SUBJECT: Response to comments by OEHHA on DPR-HHAB’s draft 1,3-dichloropropene risk assessment document (dated August 31, 2015)

Responses to OEHHA comments on HHAB’s draft 1,3-dichloropropene RCD (dated Aug. 31, 2015)

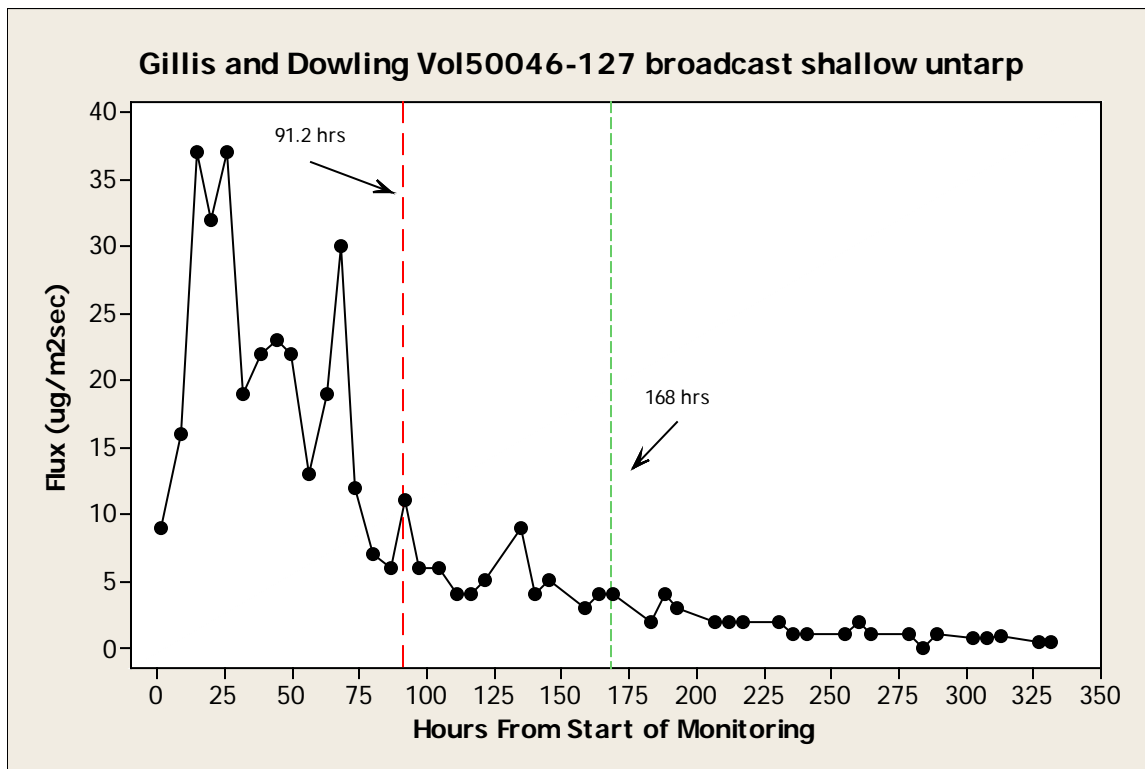
OEHHA comment #7 (page 21): Short-term exposure estimates for loaders were calculated directly from breathing-zone measurements of 1,3-D under field conditions (Houtman, 1993). The draft RCD excluded “high exposure potential activities” from the loader exposure scenario. No clear justification was provided. DPR should provide a rationale for not taking the same approach that was used by US EPA in estimating exposures for this activity.

DPR-HHAB response: The 1,3-D data obtained with spillage controls in place were used for the shank applicator scenarios because, according to the product labels, spillage controls are required for shank application in CA.

The high exposure potential activities were not excluded from the draft RCD. The sampling data used to estimate exposure included high exposure potential activities along with other activities associated with the scenario. The samples were the longest (4-hr TWA), taken in the study and were deemed more representative of the actual exposures a worker may experience over the default work period used for estimating exposure (i.e., 8-hrs/day).

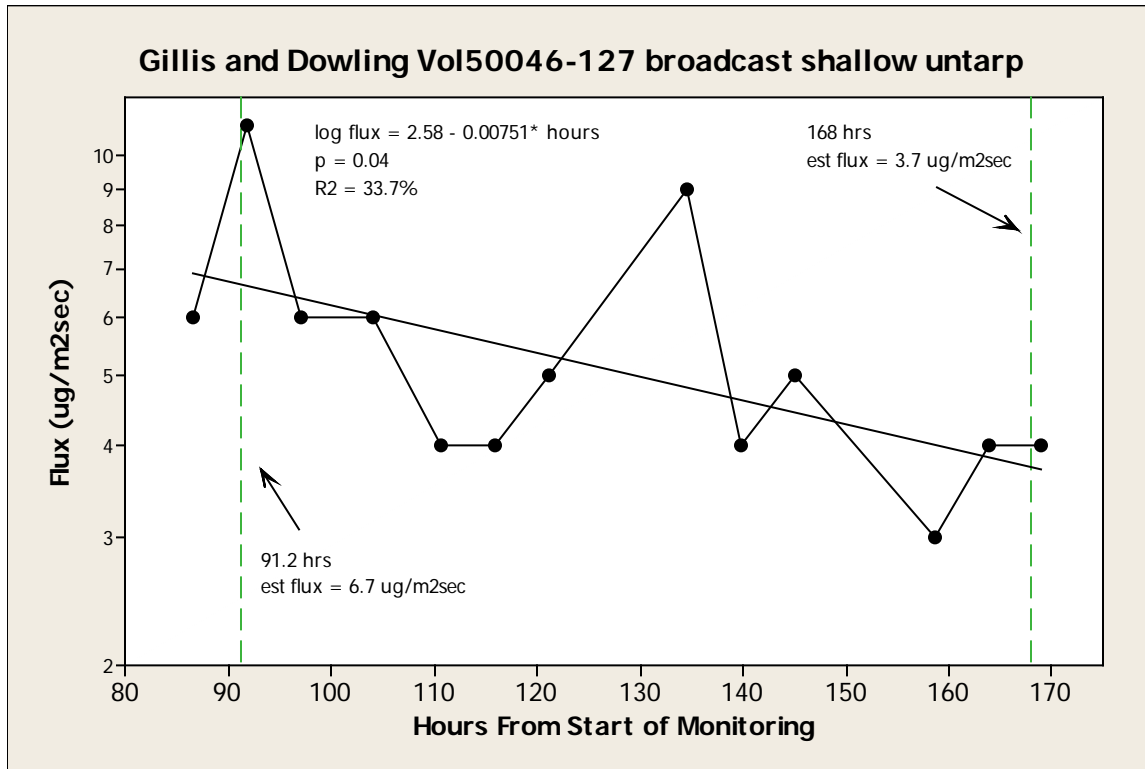
OEHHA comment #8 (page 22): OEHHA recommends that DPR (1) clarify why some activities can take place before the end of the REI and (2) estimate the uncertainty in using a study conducted 3.8 days post-fumigation as representative of all reentry activities.

The general pattern of the flux profile is exponential decline after the first peaks are reached at 15 and 37 hrs. However, it is clear that fitting that exponential would be difficult to impossible. TableCurve® software was used to fit the decline and, as expected, no acceptable fit could be found. There is a decline but fitting a single viable function is impossible. The interval between 3.8 days (91.2 hrs) and 7 days (168 hrs) is shown as vertical lines. It is clear that the flux values in this interval are not monotonically decreasing. However, it appears it is likely that the flux at 91.2 hrs is numerically larger than the flux at 168 hrs. This does not mean the flux between those two time points are statistically different.

Flux is only one of the variables that produce air concentrations to which workers will be exposed. Although it is true that in air dispersion modeling that air concentrations are directly proportional to flux, that is *with all other factors held constant*. So, the uncertainty in differences in meteorology between these two time points should be considered. In addition, if the air concentrations associated with these flux values were modeled using an air dispersion model, it should be noted that air dispersion models are considered to generally produce air concentrations within a factor of 2 of the actual air concentrations generated by that flux.

Regression analysis of the portion of the entire flux profile that falls between 86.6 hrs and 168 hrs is shown below. The regression is statistically significant, showing $p = 0.04$ for the slope. The $R^2 = 33.7\%$. While the regression is statistically significant it is clear that the linear function fits poorly. The estimated fluxes are $6.7 \text{ ug/m}^2\text{sec}$ and $3.7 \text{ ug/m}^2\text{sec}$ for 91.2 hrs and 168 hrs, respectively. The ratio of 3.7 to 6.6 is 0.55. So, the flux at 91.2 hrs is slightly less than double the flux at 168 hrs.

In summary, uncertainty is created by the lack of a monotonically decreasing flux profile in the area of interest (91.2 hrs to 168 hrs), the resulting poor fit of the regression, and the air dispersion model factor of two acceptability. Another potential source of uncertainty is the analytical variability of the study.
